**From:** Quamme, Jeff  
**Sent:** Friday, February 07, 2014 1:21 PM  
**To:** Parks, Timothy; Dailey, Janet  
**Cc:** Pederson, Eric  
**Subject:** FW: 80 White Oaks Ln Comments

**From:** Rick Morgan [REDACTED]  
**Sent:** Saturday, February 08, 2014 1:07 PM  
**To:** Phair, Matthew; Parks, Timothy  
**Cc:** [REDACTED]  
**Subject:** White Oak Ridge #2

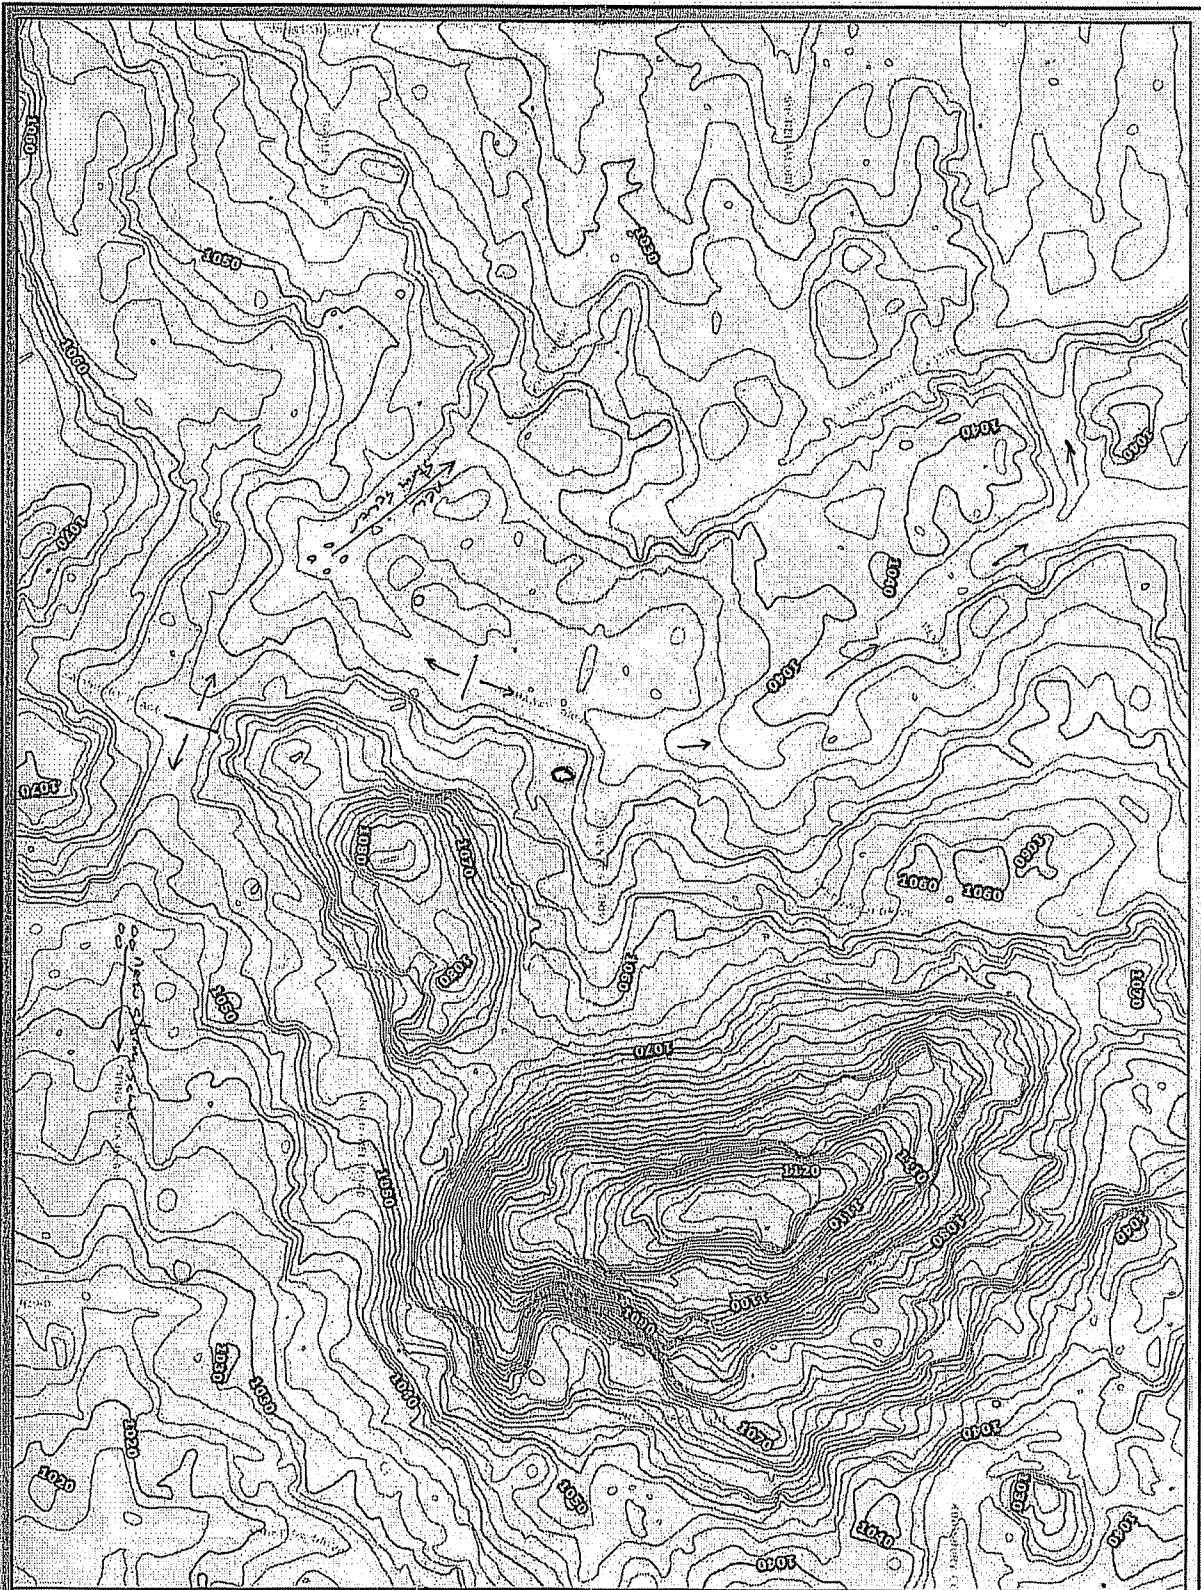
I believe that the biggest concern for me and my neighbors is the storm water runoff from the new development. While I see that the City is proposing rain gardens and catch basins, these items require maintenance by the homeowners and I am not convinced that they will be maintained properly to deal with the potential problem long term. I believe the ultimate answer is a connection to the storm sewer at the end of Davenport drive and urge the city to place this higher on the priority list to get upgraded. Other approaches need to be carefully considered for short and long term functionality.
